Serial No. 04-380
NL&OS/ETS R0
Docket Nos. 50-338/339
License Nos. NPF-4/7

VIRGINIA ELECTRIC AND POWER COMPANY
NORTH ANNA POWER STATION UNITS 1 AND 2
PROPOSED TECHNICAL SPECIFICATIONS CHANGE REQUEST
REACTOR COOLANT SYSTEM PRESSURE/TEMPERATURE LIMITS
LTOPS SETPOINTS AND LTOPS ENABLE TEMPERATURES

**Virginia Electric and Power Company
North Anna Power Station Units 1 and 2
Proposed Technical Specification Changes for
Reactor Coolant System Pressure/Temperature Limits
LTOPS Setpoints and LTOPS Enable Temperatures**

Figure 3.4.3-1 (page 1 of 1)
Unit 1 RCS Heatup Limitations
Heatup Rates up to 60°F/hr, Applicable for the first 32.3 EFY,
Including Margins for Instrumentation Errors

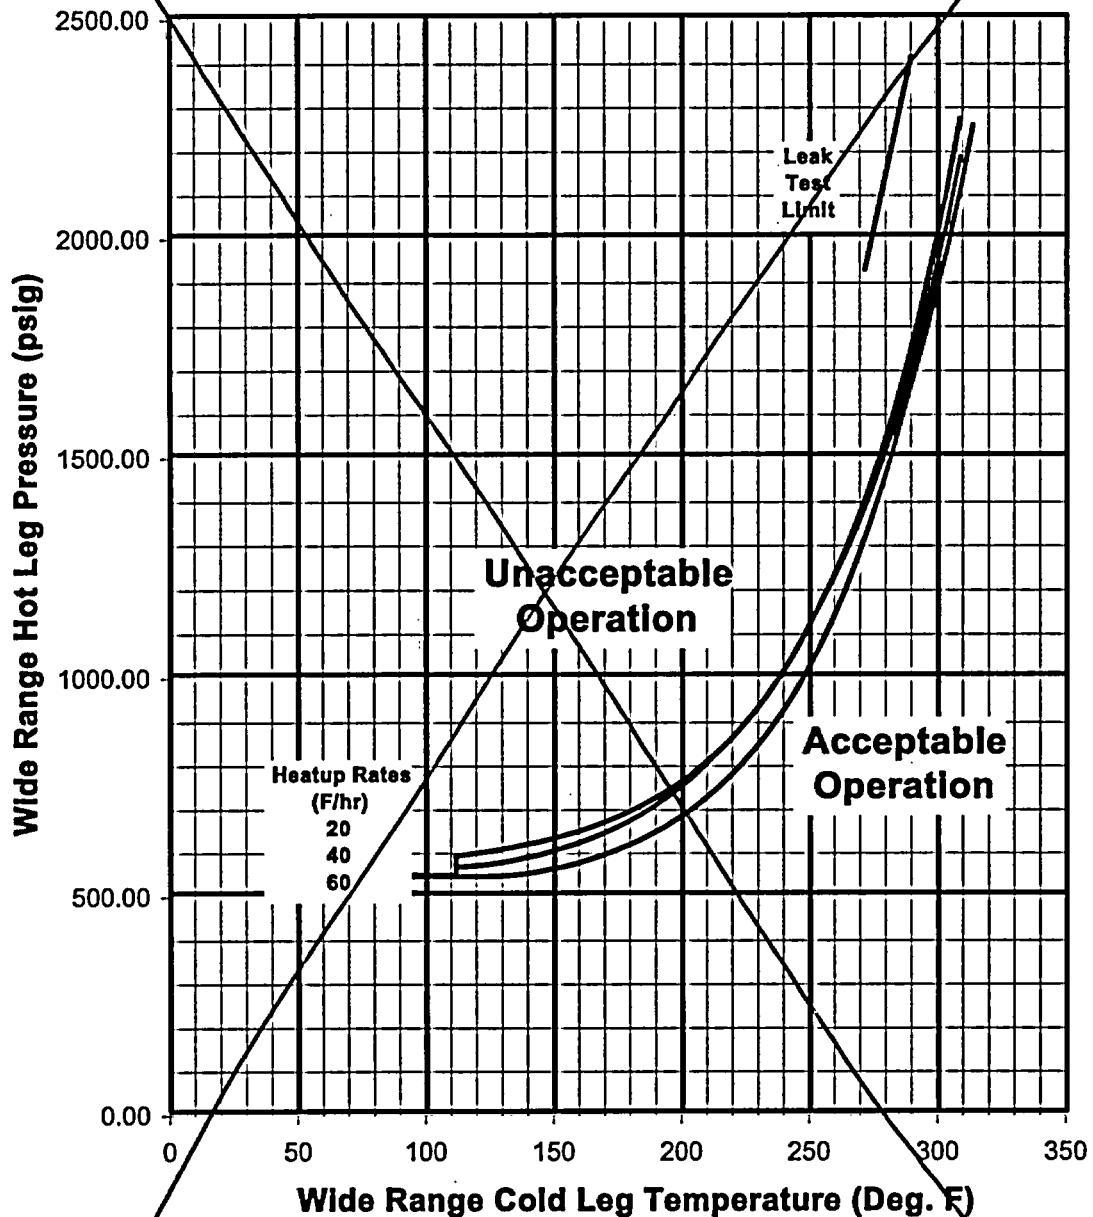
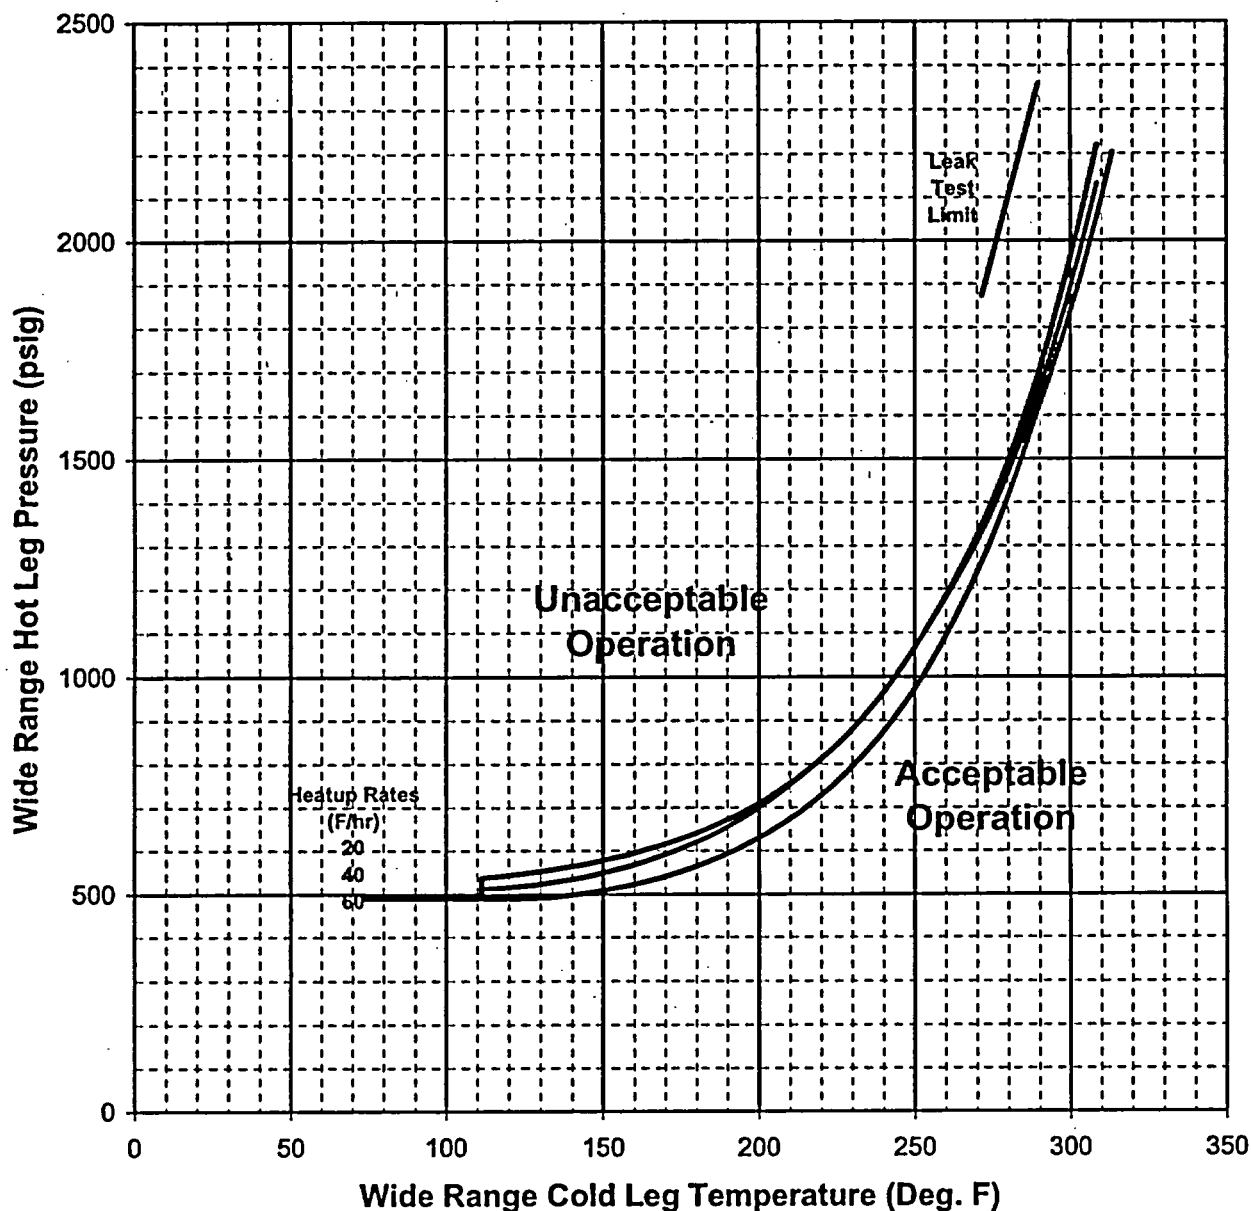
Technical Specification 3.4.3: Figures 3.4.3-1, 3.4.3-2, 3.4.3-3 and 3.4.3-4 and the cumulative core burnup limits are being replaced by revised Figures 3.4.3-1 and 3.4.3-2, Reactor Coolant System Heatup and Cooldown Limitations. The proposed curves will be valid for both North Anna Units 1 and 2.

delete - replace with new
FIGURE 3.4.3.1

NEW FIGURE 3.4.3-1

Figure 3.4.3-1 (page 1 of 1)
North Anna Units 1 and 2 Reactor Coolant System Heatup Limitations
(Heatup Rates up to 60°F/hr),
Applicable for the first 50.3 EFPY for Unit 1, and 52.3 EFPY for Unit 2
(Including Margins for Instrumentation Errors)

Figure 3.4.3-2 (page 1 of 1)
Unit 1 RCS Cooldown Limitations
Cooldown Rates up to 100°F/hr, Applicable for the first 32.3 EFPY,
Including Margins for Instrumentation Errors

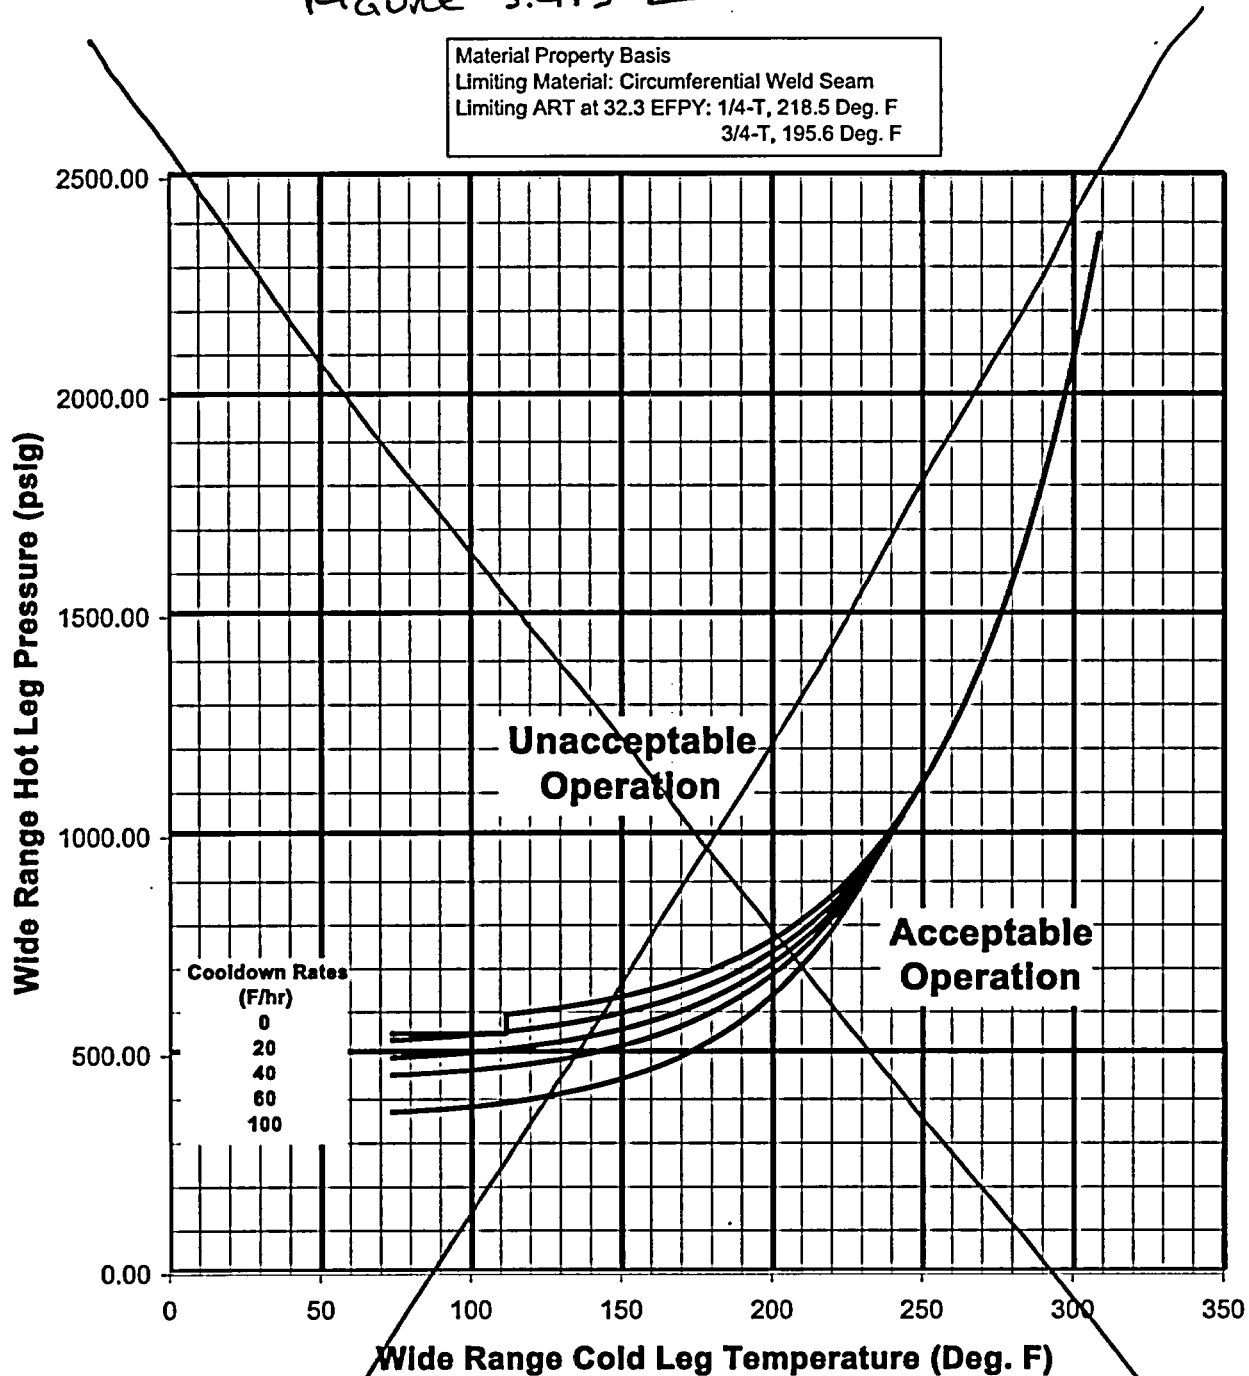
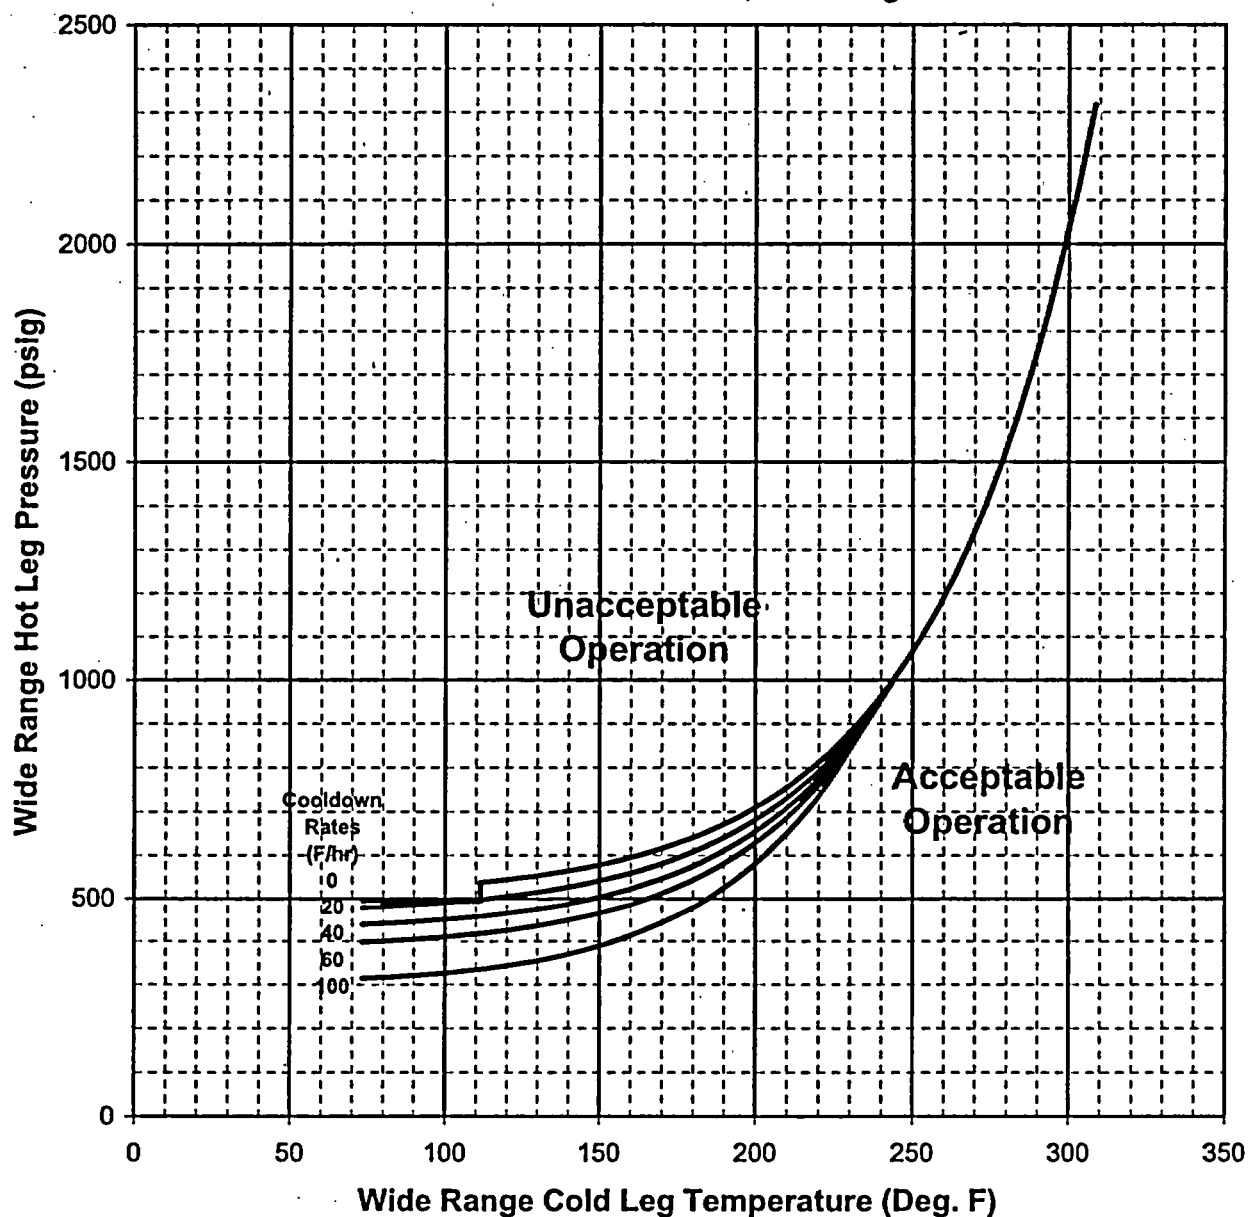
Delete-Replace WITH NEW
FIGURE 3.4.3-2

NEW FIGURE 3.4.3-2

Figure 3.4.3-2 (page 1 of 1)
North Anna Units 1 and 2 Reactor Coolant System Cooldown Limitations
(Cooldown Rates up to 1000°F/hr),
Applicable for the first 50.3 EFPY for Unit 1, and 52.3 EFPY for Unit 2
(Including Margins for Instrumentation Errors)

Figure 3.4.3-3 (page 1 of 1)
Unit 2 RCS Heatup Limitations
Heatup Rates up to 60°F/hr, Applicable for the first 34.3 EFPY,
Including Margins for Instrumentation Errors

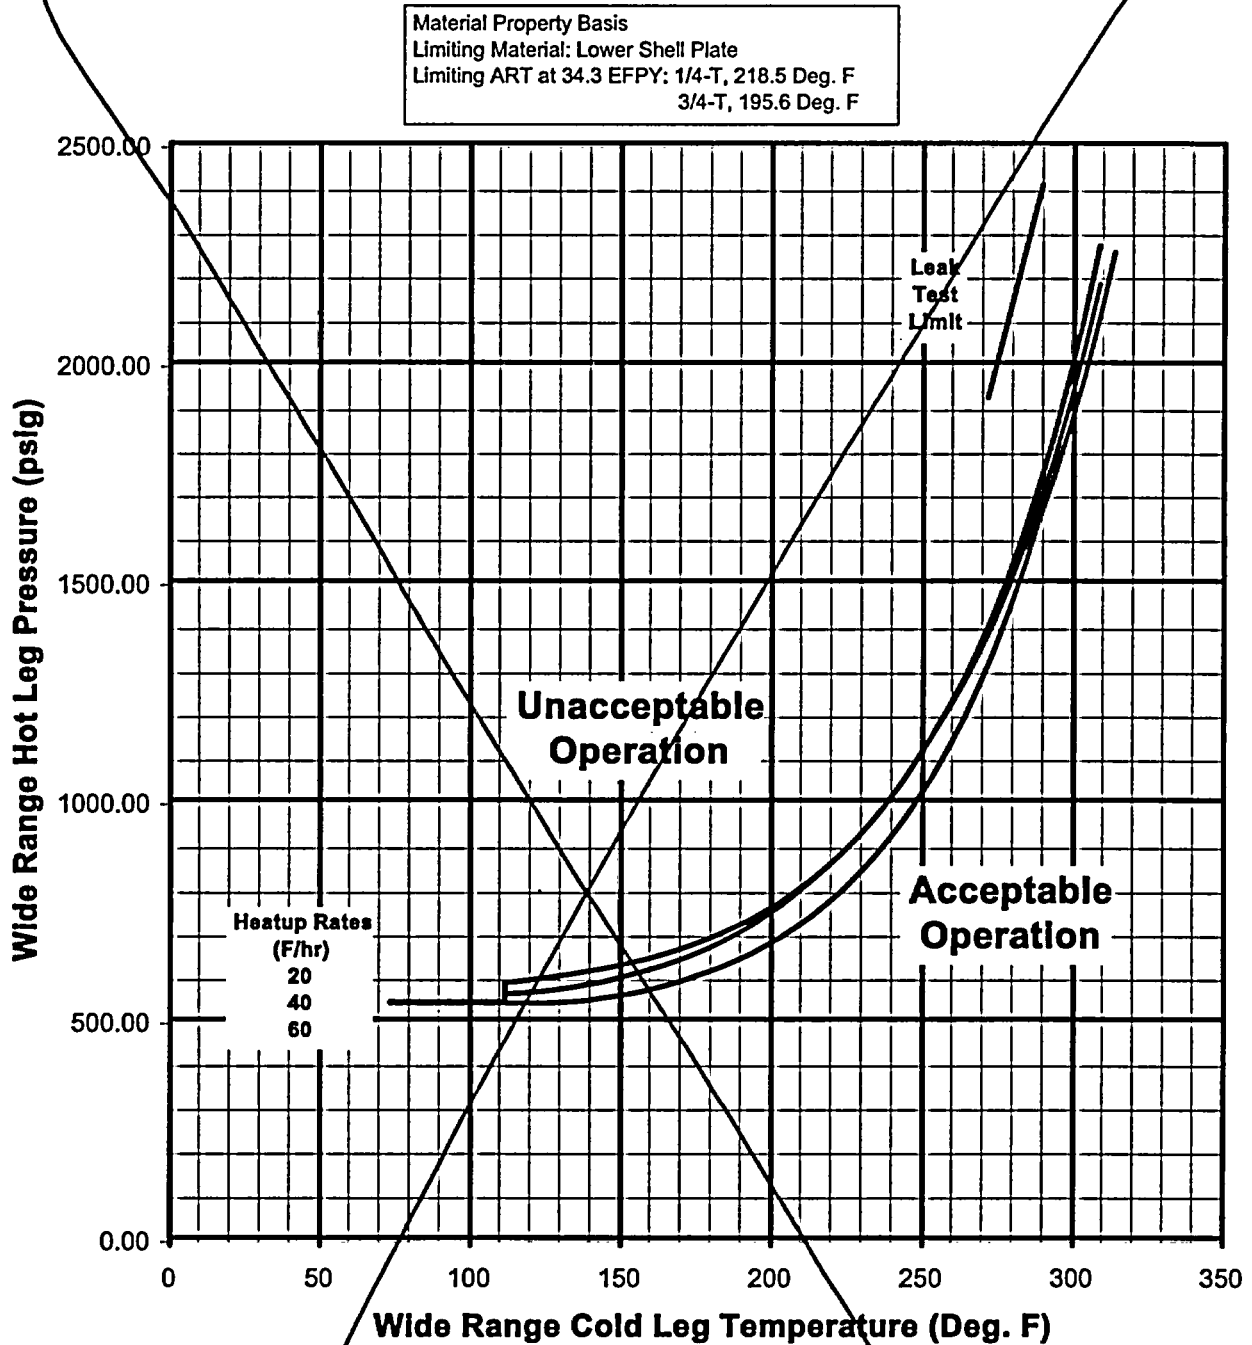
DELETE

Figure 3.4.3-4 (page 1 of 1)
Unit 2 RCS Cooldown Limitations
Cooldown Rates up to 100°F/hr, Applicable for the first 34.3 EFPY,
Including Margins for Instrumentation Errors

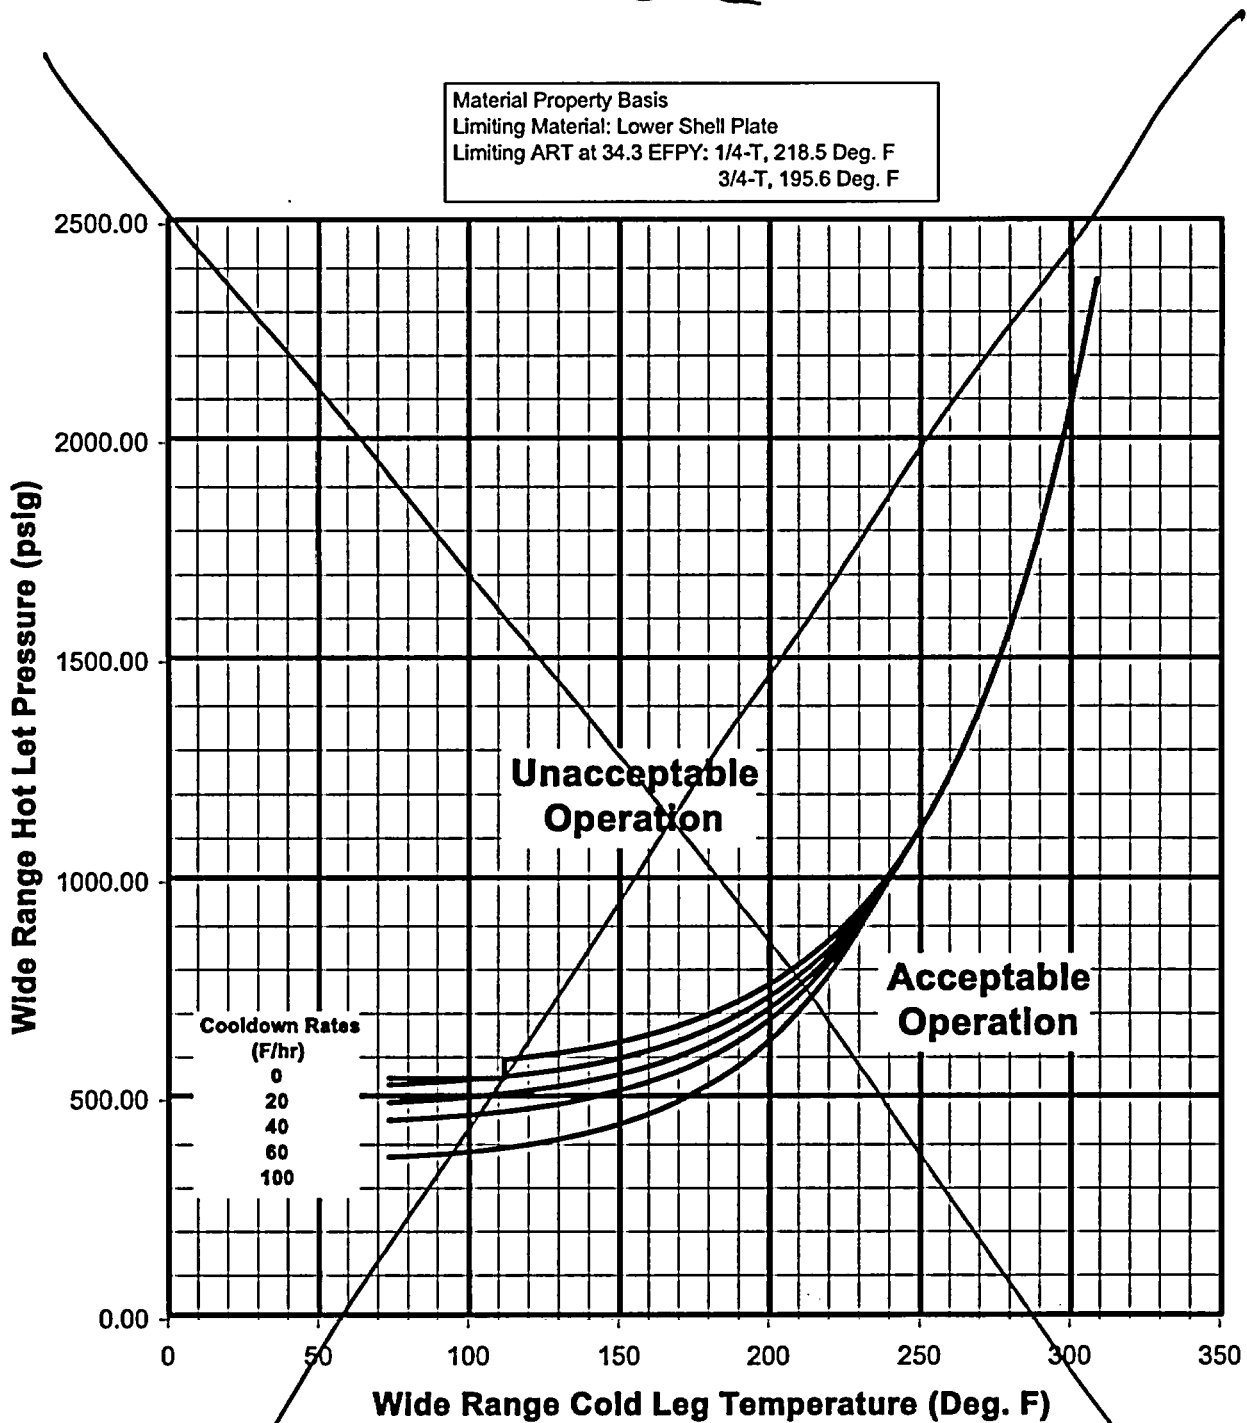
DELETE
